VILLAGE BOARD AGENDA
Wednesday, July 8, 2026 at 7:00 PM

1. Plan Commission Recommendations 6.24.26

To: Village of Mount Horeb Plan Commission
From: Village Planner: Ben Rohr, AICP
Date: June 24, 2026
Re: Specific Implementation Plan (SIP) and Design Review for 21 Proposed Single-Family Homes at the Southern End of Brookview Trail for Brookstone South, LLC.

Graphic Scale	0' 10' 20' 30'
Wysers Number	24-1229
Set Type	REVIEW
Date Issued	05/07/2026
Sheet Number	C202

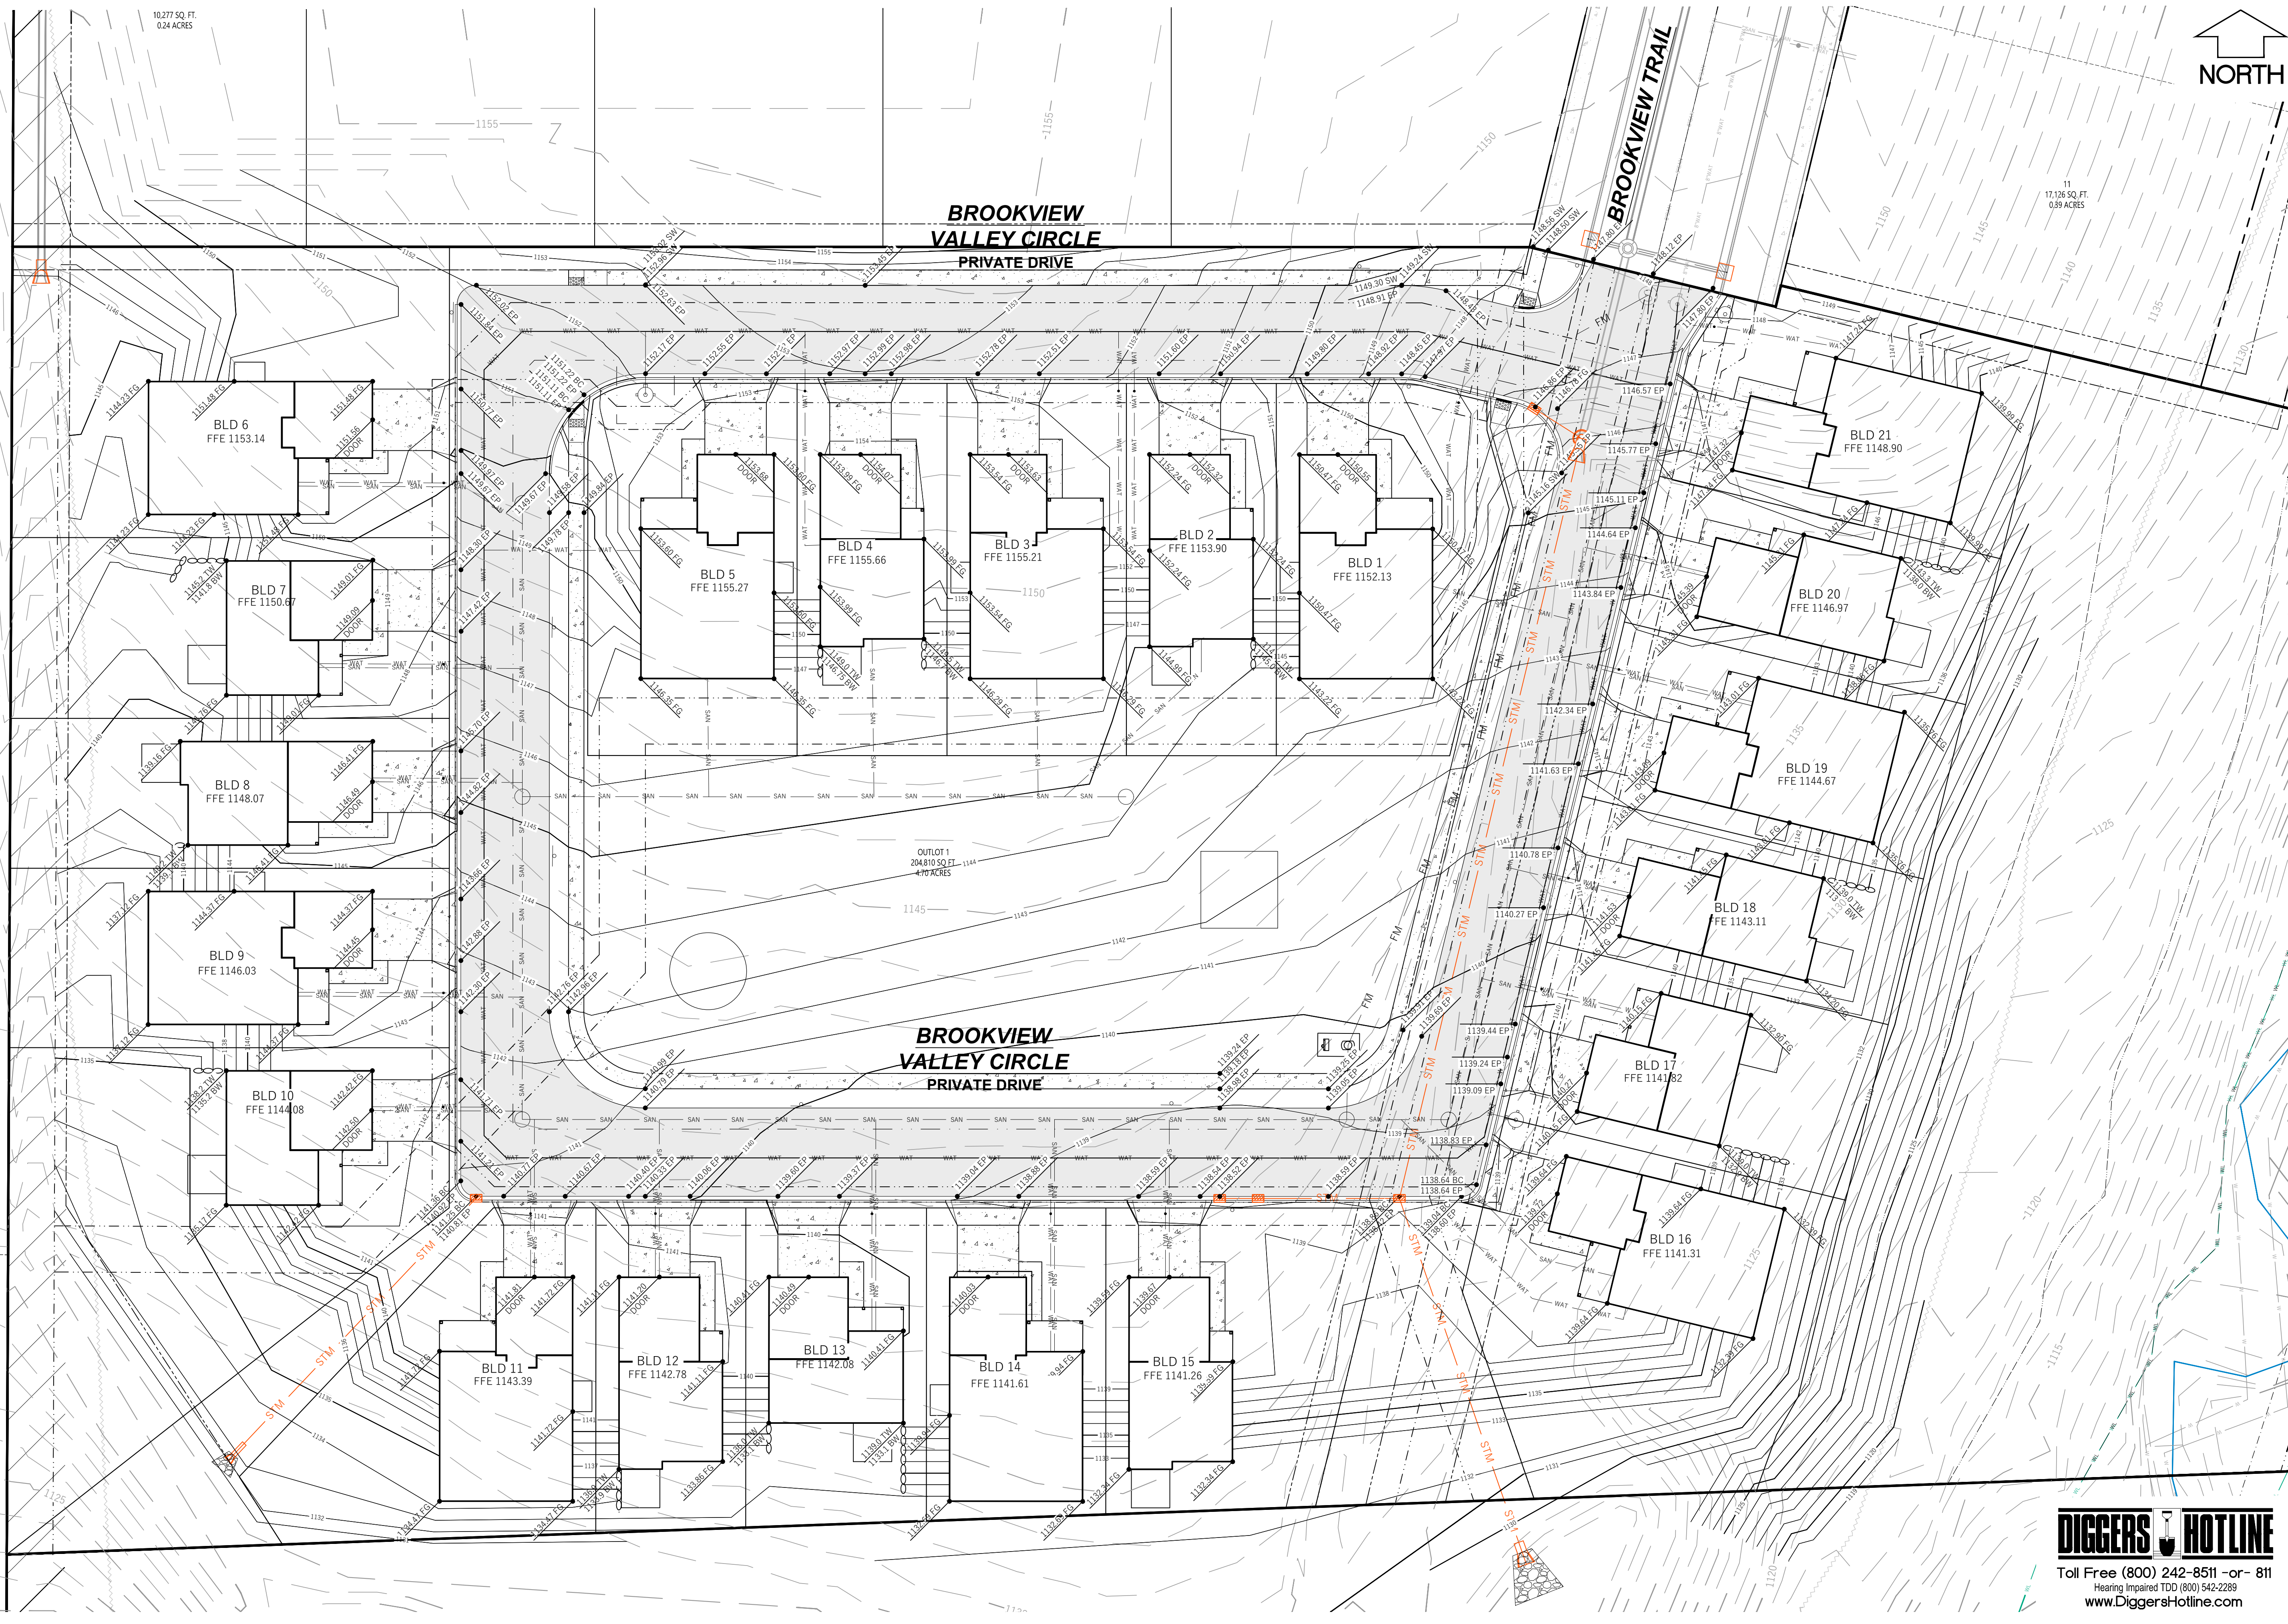
- a. The grading plan shall preserve existing grades to the greatest extent possible, particularly at the perimeter of the site.
 - This requirement is met. The site includes sloping grades in multiple directions. The Grading Plan works within the existing grade changes to maintain topography to the extent possible.
- b. In no instance shall proposed grading create transitions to adjoining properties or rights-of-way that are unsafe, unstable or create drainage problems.
 - This requirement is met. Existing grade transitions to adjacent properties are maintained to the extent possible.
- c. Site grading shall also preserve or create an attractive site appearance in conjunction with the proposed development.
 - This requirement is met. Existing site grades are maintained to the extent possible.

7. Village Engineer review and approval of the proposed Stormwater Management and Grading Plans.

XXX 4 of 5 pages **A3.0**

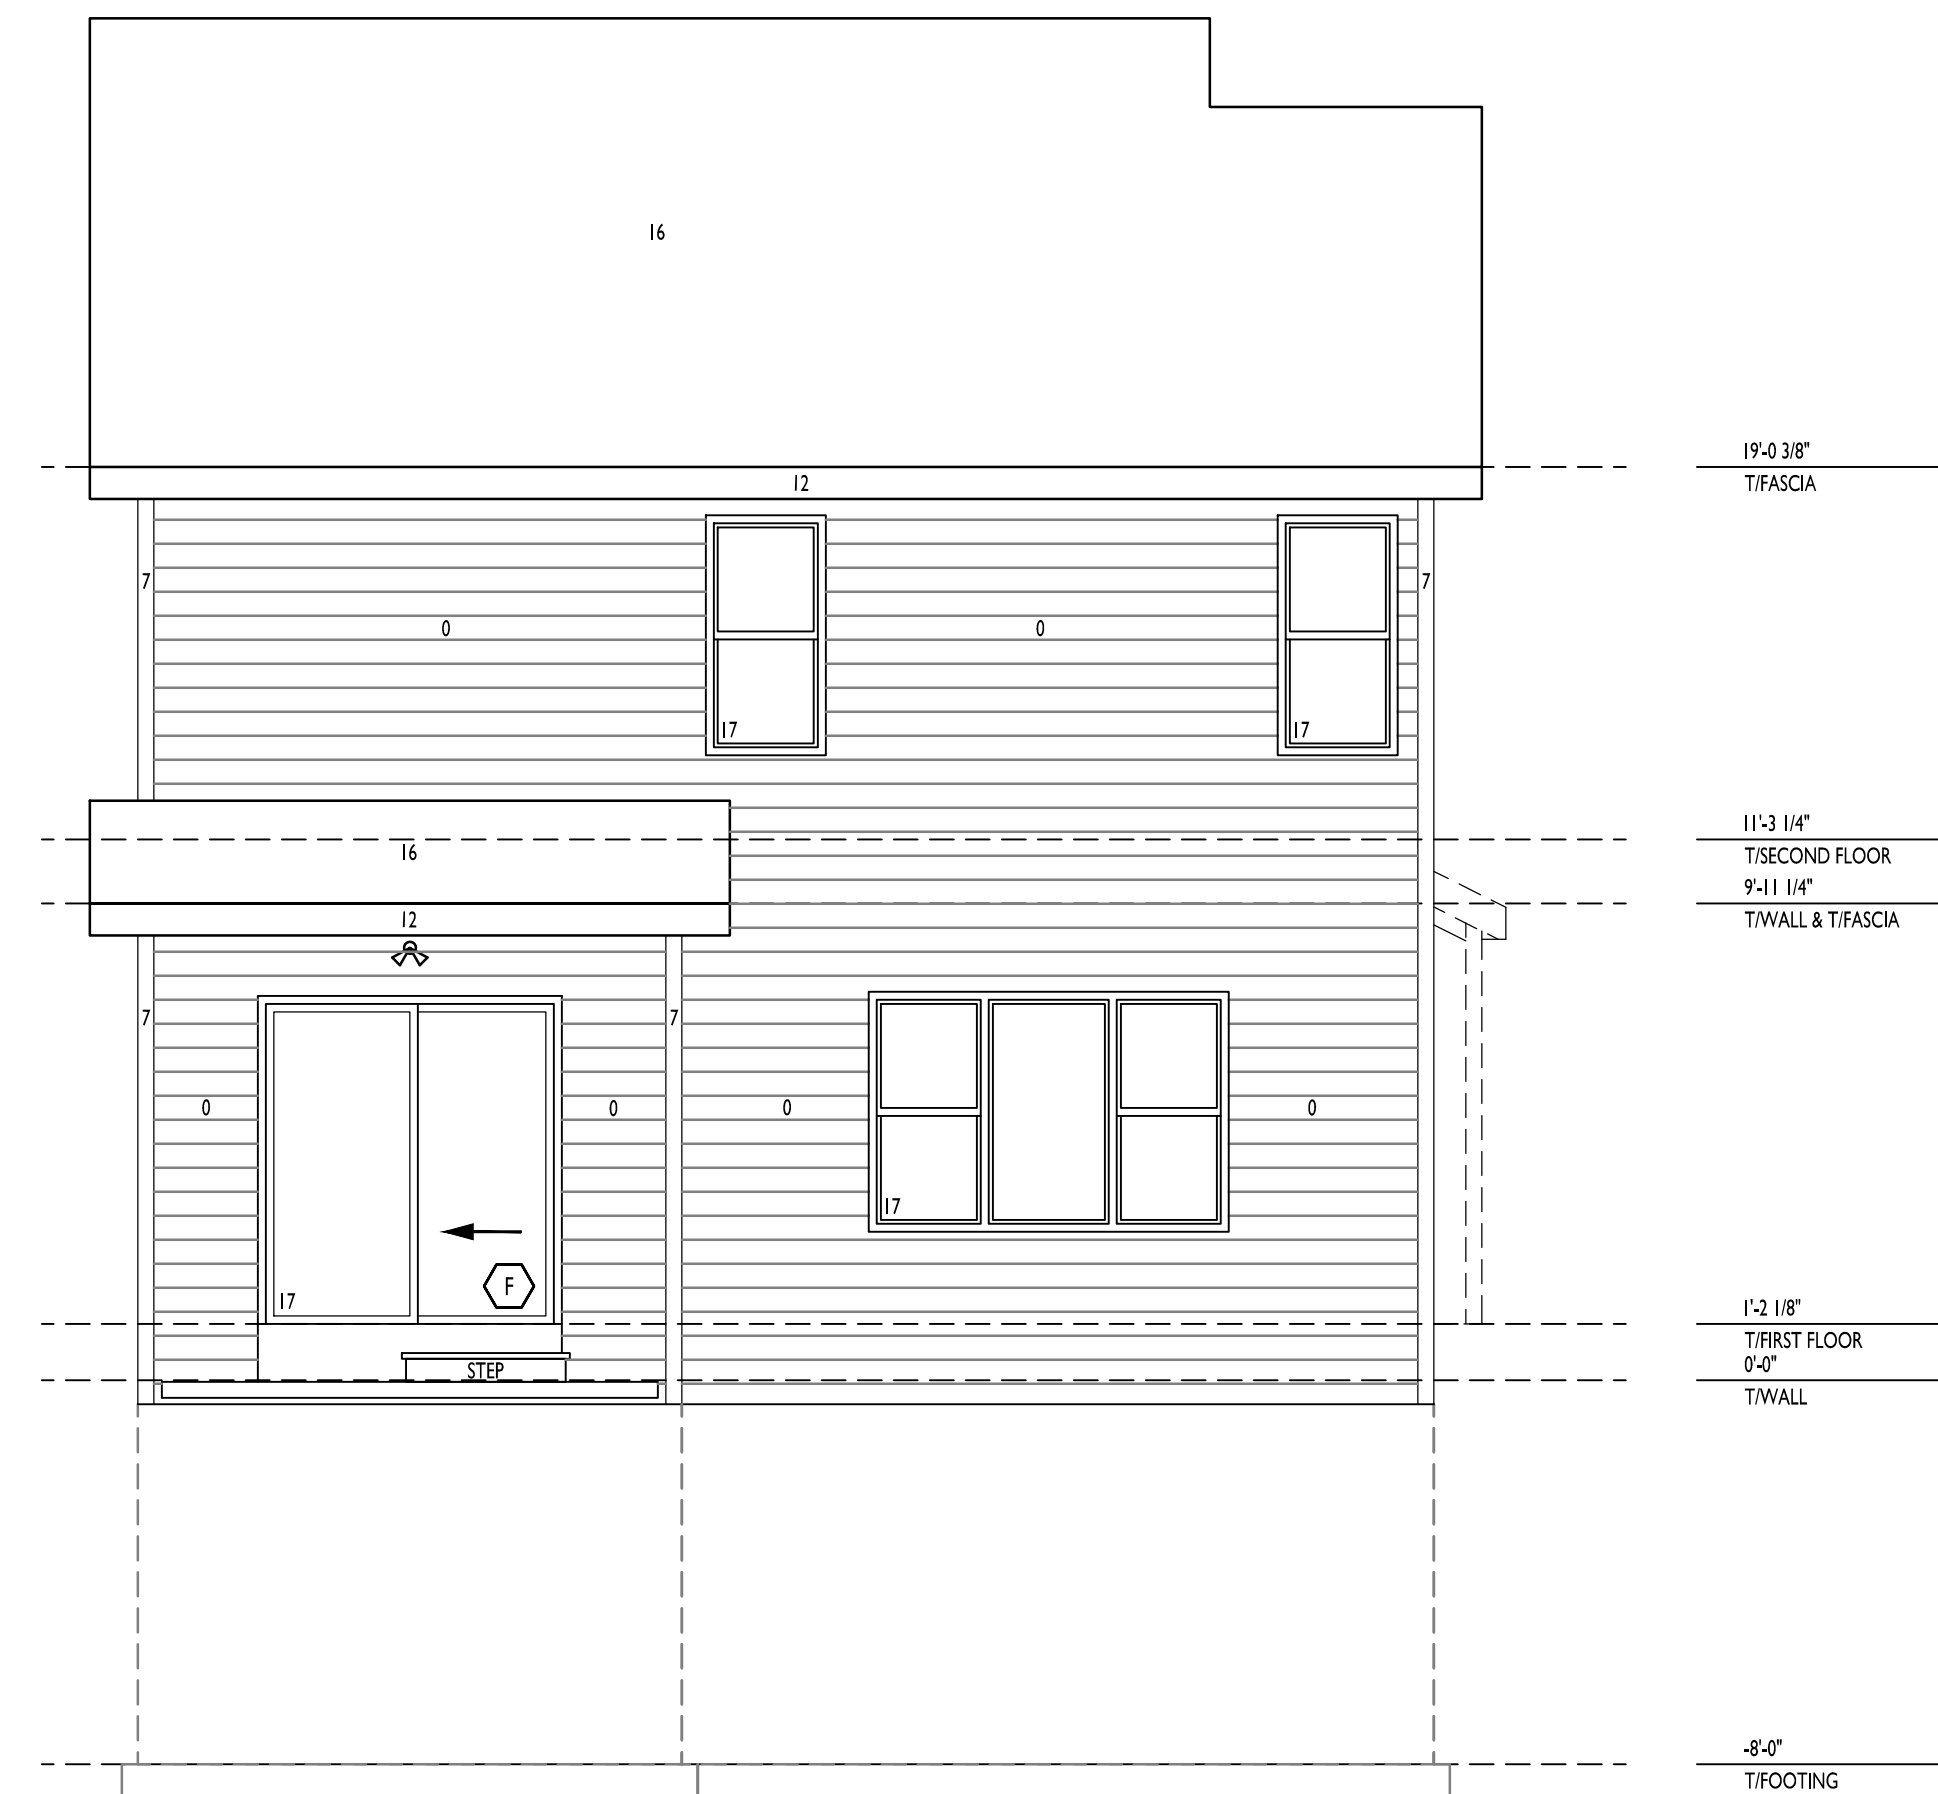
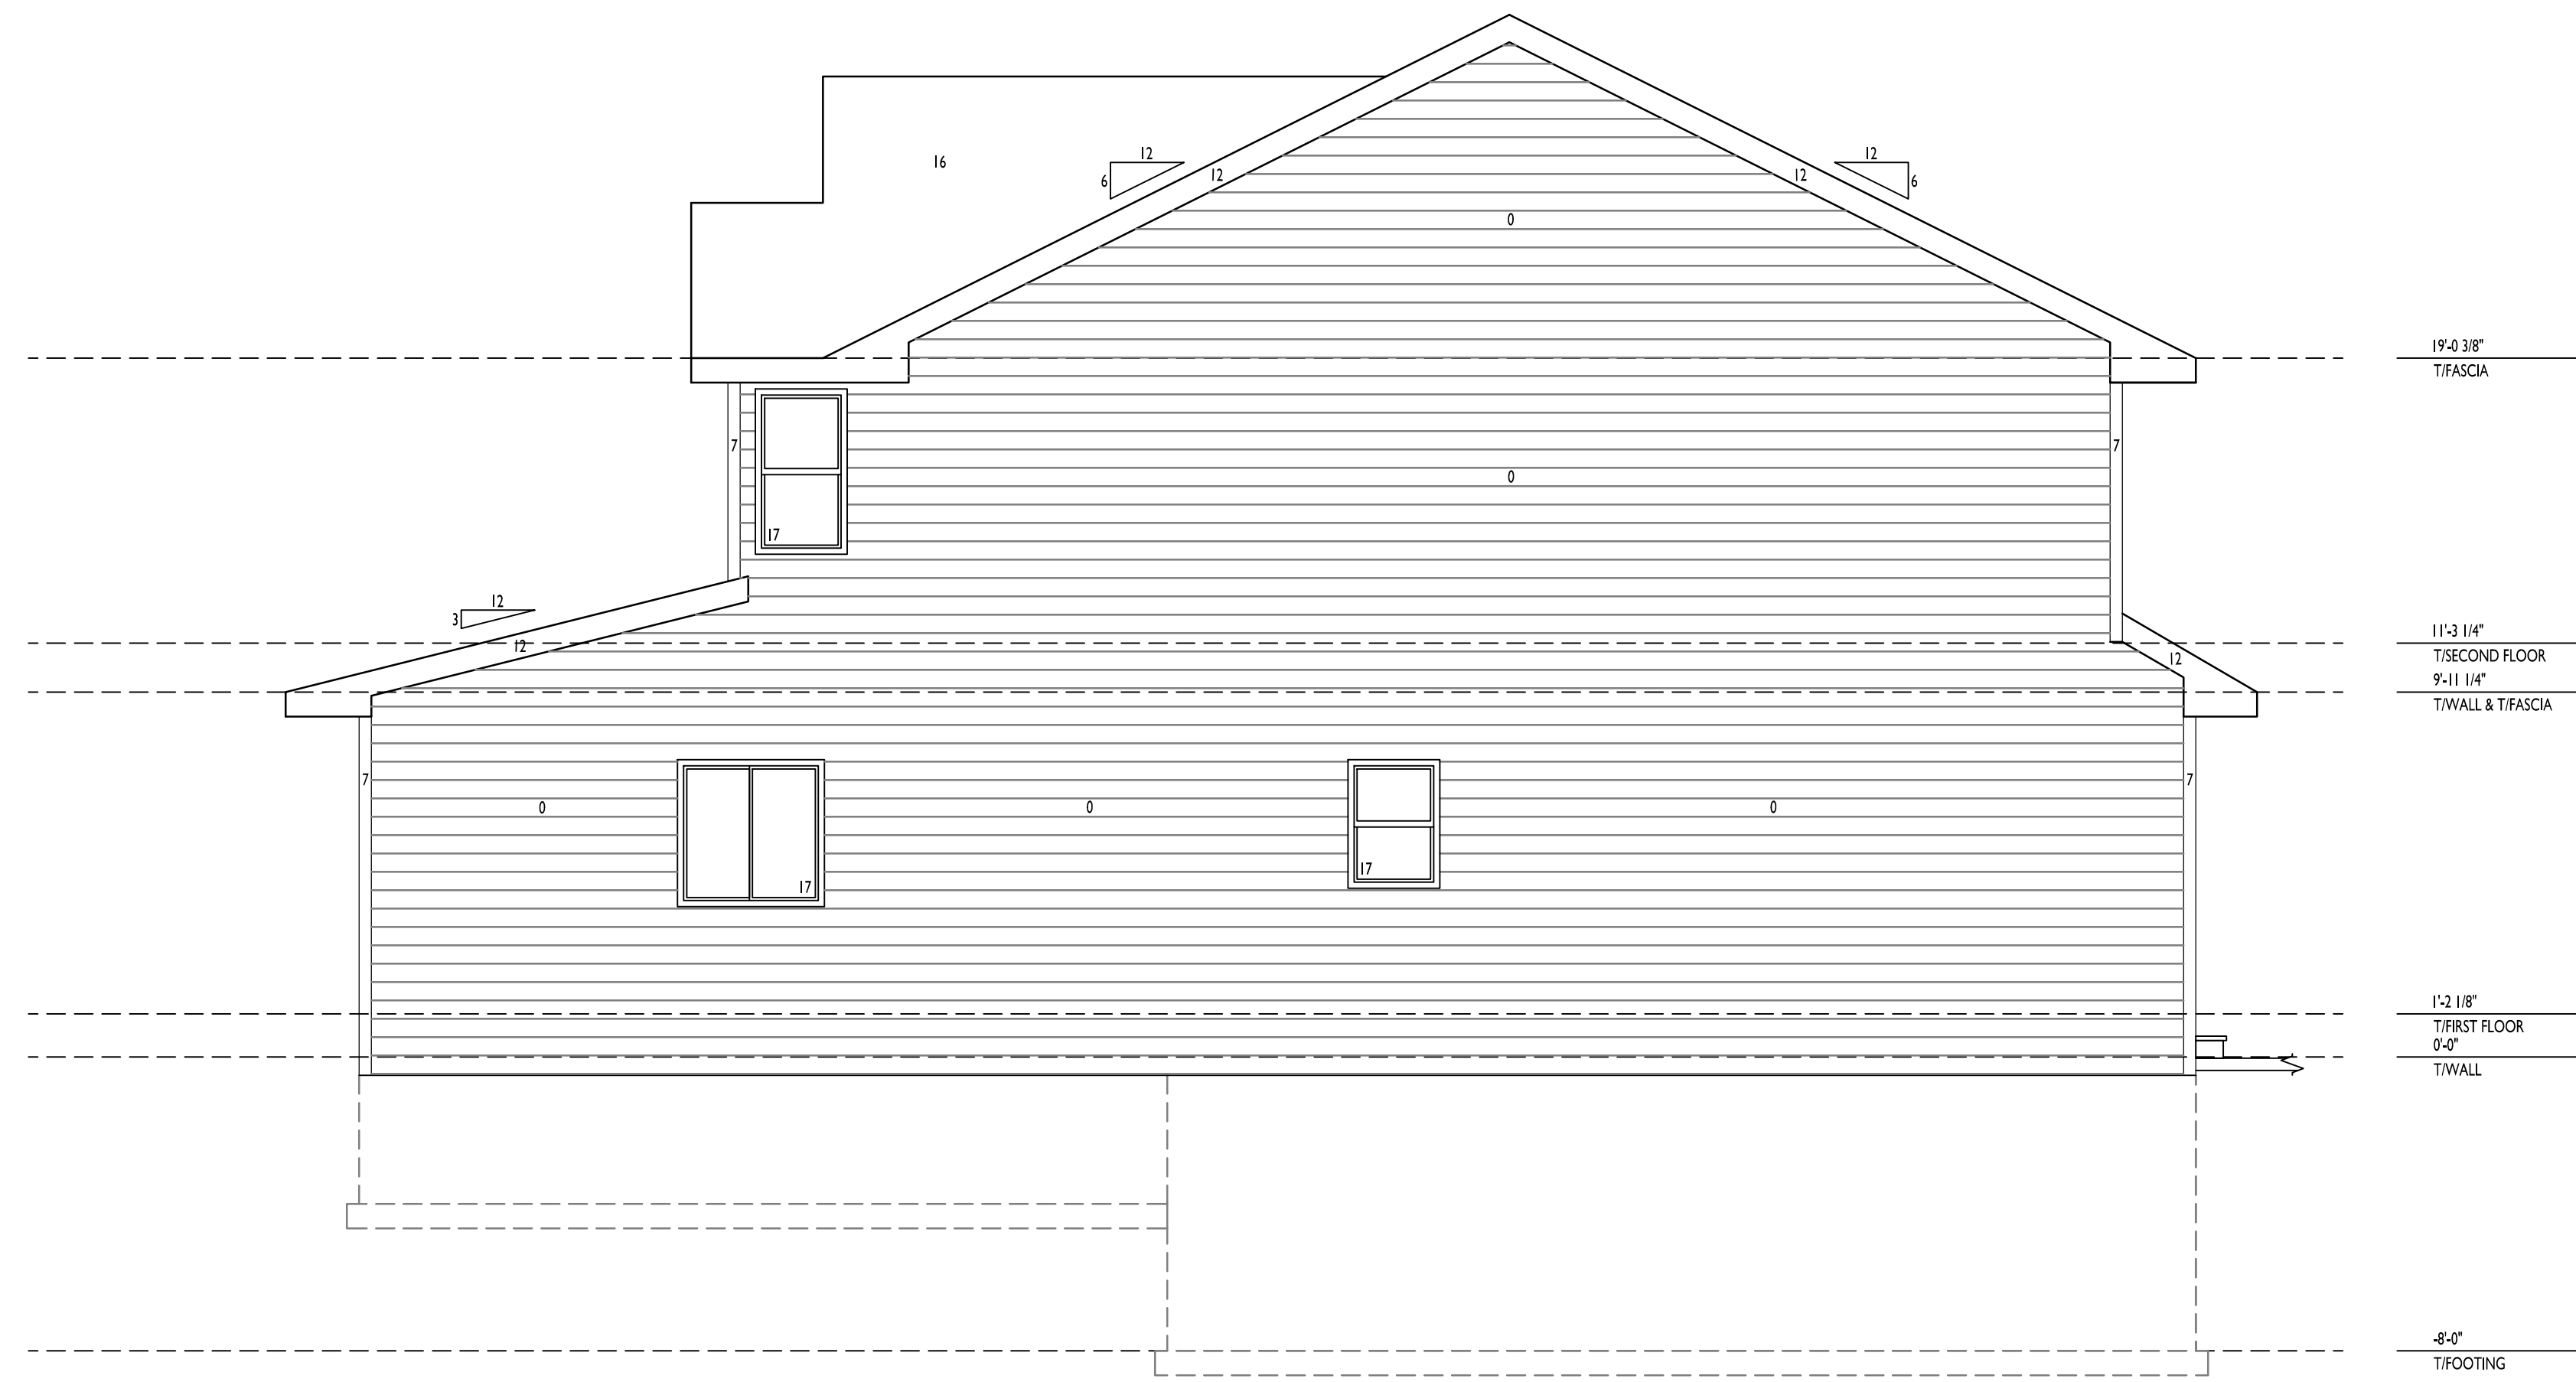
- a. Long building facades shall be visually broken up and variegated with staggers and offsets as determined appropriate by the Plan Commission.
 - This requirement is met on the front and rear elevations of each unit through varying roof pitches, windows, and doors. This requirement is not met along the side facades of each structure where very little articulation is proposed. Because each unit will be 12 feet apart, limited widow openings are necessary to provide privacy between the units. Additionally, this project is more in line with a single-family neighborhood where there are often longer building facades without articulation. I recommend the Plan Commission waive this requirement for the side facades for these reasons.

- This requirement may be met. The prominence of the front-loaded garage was discussed during the GDP and concept review meetings for this project. I recommend the Plan Commission discuss this requirement again.

- This requirement may be met. The prominence of the front-loaded garage was discussed during the GDP and concept review meetings for this project. I recommend the Plan Commission discuss this requirement again.

- This requirement is not met. No architectural base feature is included within any proposed unit type. I recommend that the Plan Commission discuss this item further.

5. Plan Commission Action on (related to requirement 7.b. and c.):
 - a. Requiring resubmittal with an alternative front façade design that further reduces the prominence of the front-loaded garages to include:

6. Plan Commission Action on (related to requirement 8.b.):
 - a. Requiring resubmittal with an alternative front façade design that includes a 40" hard durable base material to include:
